Village of Arlington Heights
Plat and Subdivision Committee
Community Room, 3rd Floor
Arlington Heights Village Hall
33 S. Arlington Heights Road
Arlington Heights, IL 60005
July 22, 2015
6:30 PM

Item: 1510 E. Northwest Highway - T1507

Item: 608-614 N. Haddow Ave. - T1508

To: Plat & Subdivision Committee
Prepared By: Derek Mach, Landscape Planner
Meeting Date: July 22, 2015
Date Prepared: July 15, 2015
Project Title: Lot Consolidation for 608-614 N. Haddow Avenue
Address: 608-614 N. Haddow Avenue

ALTERATIONS AND ADDITION FOR
THE KURZYNSKI RESIDENCE
614 N. HADDOW AVE.
ARLINGTON HEIGHTS, ILLINOIS

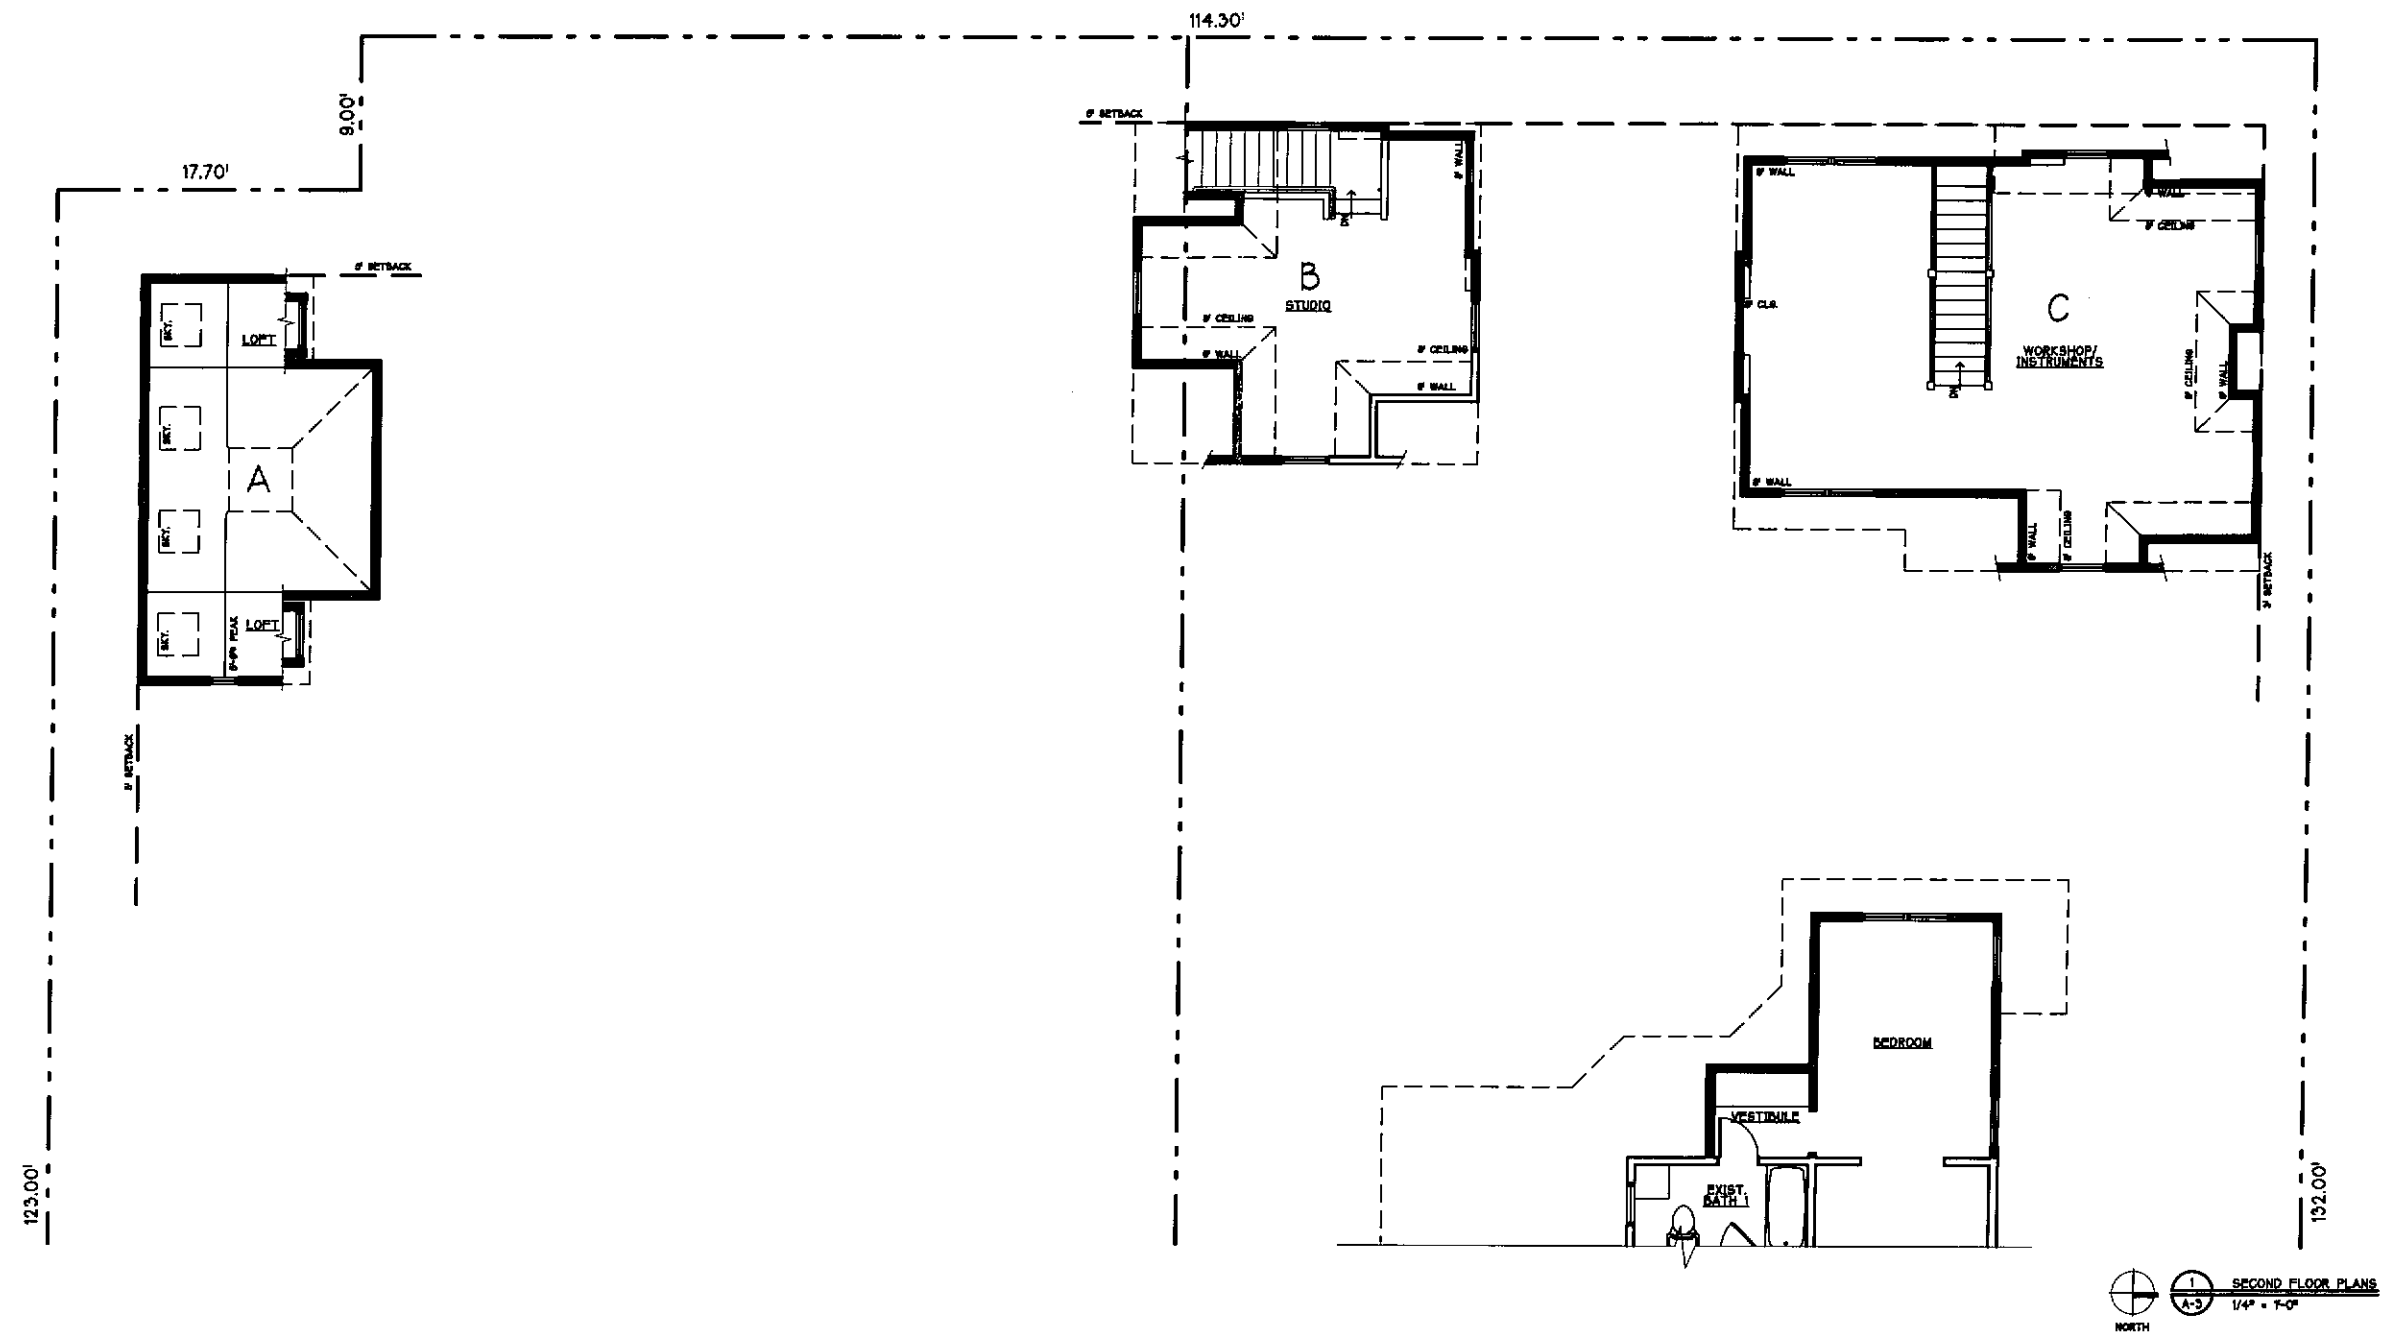
5. Identify what the basement will be used for that is shown for accessory structure 'B'.
6. Provide justification for the height variations.
7. Provide landscaping along the west property line to help buffer the three proposed accessory structures.

5. Identify what the basement will be used for that is shown for accessory structure 'B'.
6. Provide justification for the height variations.
7. Provide landscaping along the west property line to help buffer the three proposed accessory structures.
